RE: Amended Plat of Waterfront West  
Sanders County  
E.Q. #17-1947

STATE OF MONTANA  
DEPARTMENT OF ENVIRONMENTAL QUALITY  
CERTIFICATE OF SUBDIVISION PLAT APPROVAL  
(Section 76-4-101 et seq.)

E.Q. #17-1947

THIS IS TO CERTIFY THAT the plans and supplemental information relating to the subdivision known as **Amended Plat of Waterfront West**

AMENDED WATERFRONT WEST E.Q. #17-1947  
PROPOSED DRIVEWAY AND DITCH CROSS SECTION

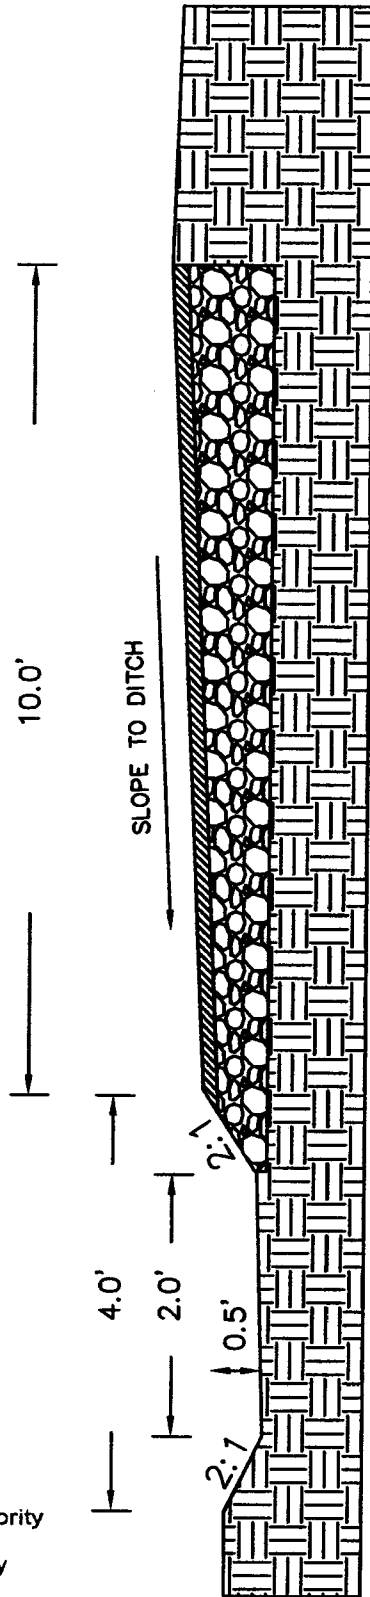
THAT the storm water conveyance and retention for the access roads shall be constructed as indicated on the approved Driveway and Ditch Cross Section and shall discharge to the existing subdivision roads and the natural drainage swale as shown on the approved lot layout, and,

# LOT LAYOUT

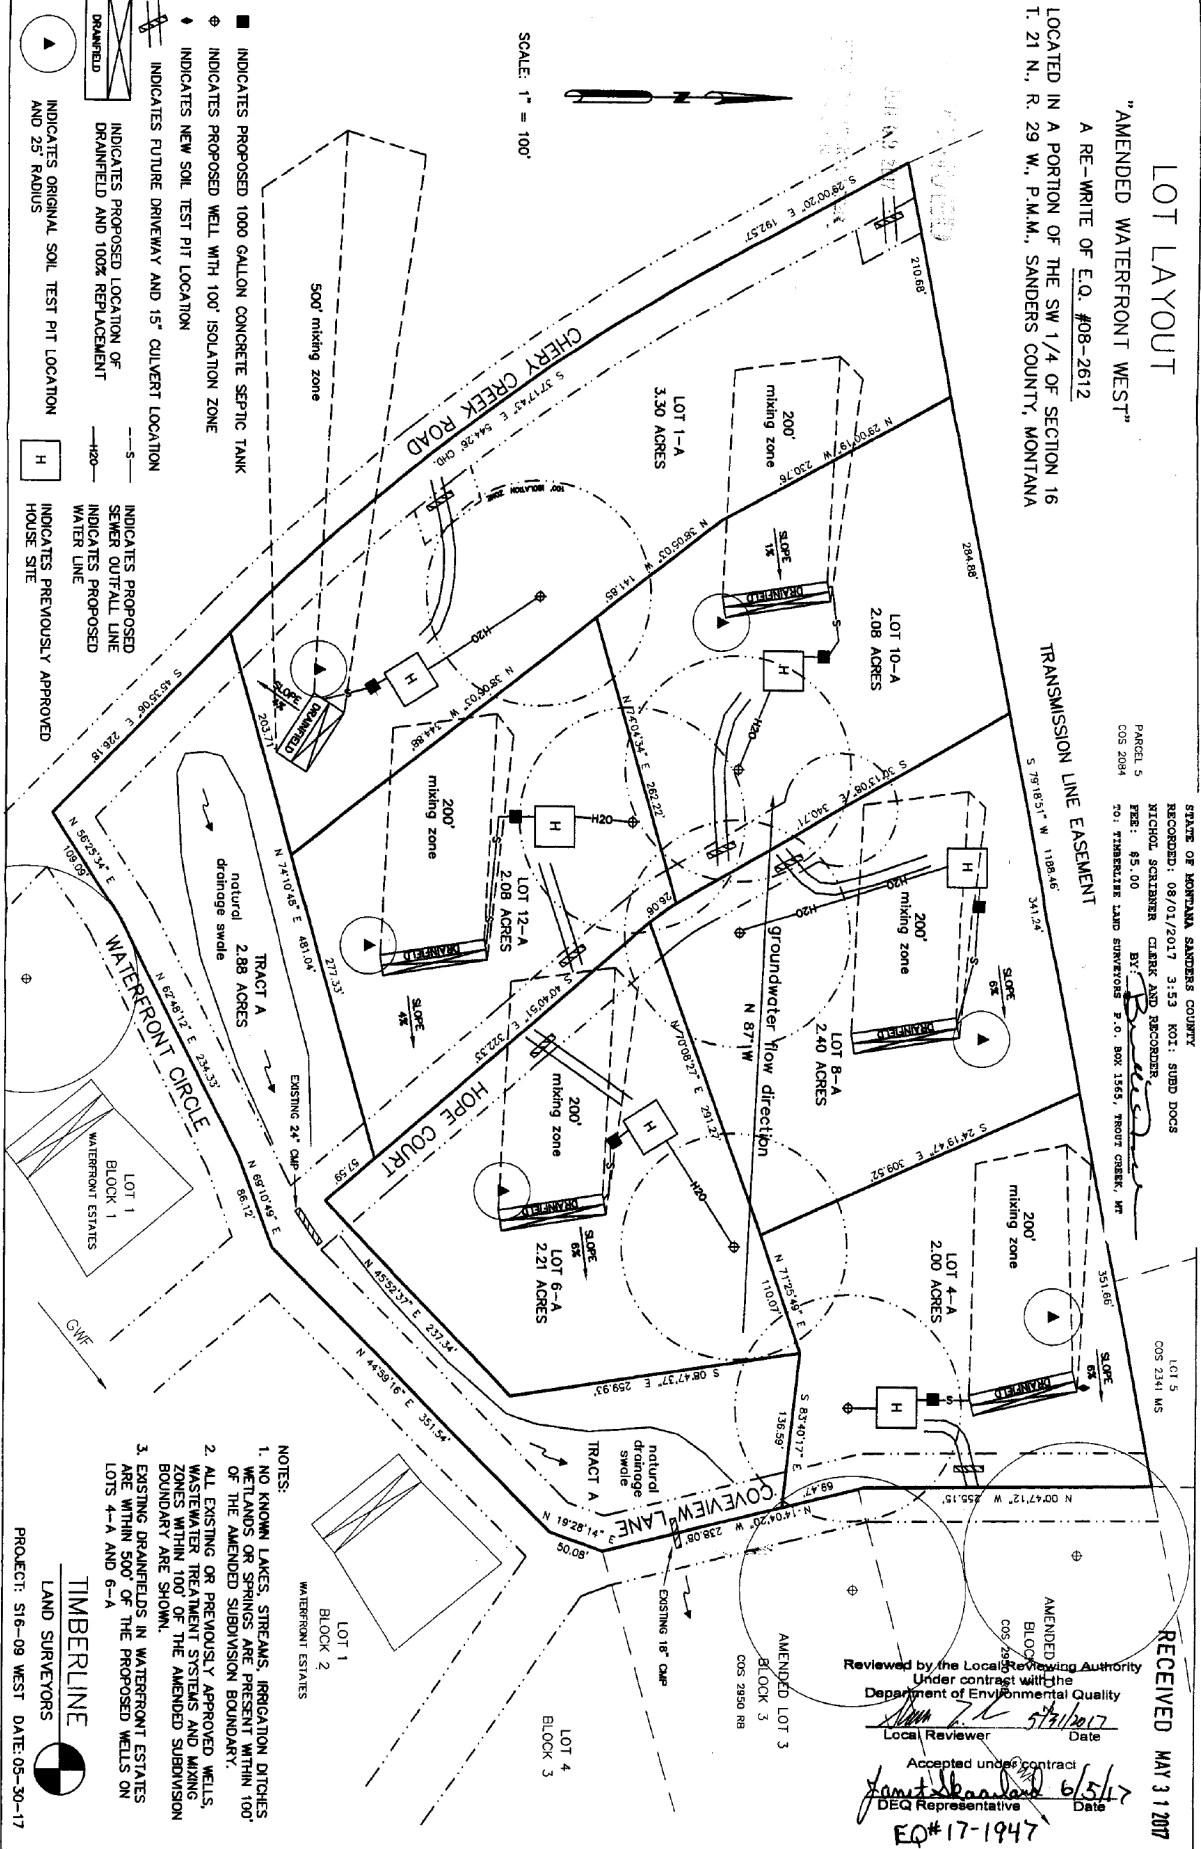
THAT the subsurface drainfield absorption area for **Lot 1-A** shall consist of three (3) – 63 foot laterals, and the subsurface drainfield absorption areas for all other lots shall consist of two (2) – 94 foot laterals, all based on three (3) bedroom living units, and,

and discharge storm runoff into the existing subdivision roads and the natural drainage swale as shown on the approved lot layout, and,

THAT water supply systems, sewage treatment systems, and storm drainage systems will be located as shown on the approved lot layout, and,

THAT the developer and/or owner of record shall provide the purchaser of property with a copy of the approved location of water supply, sewage treatment system, and storm drainage structures as shown on the attached lot layout, and a copy of this document, and,
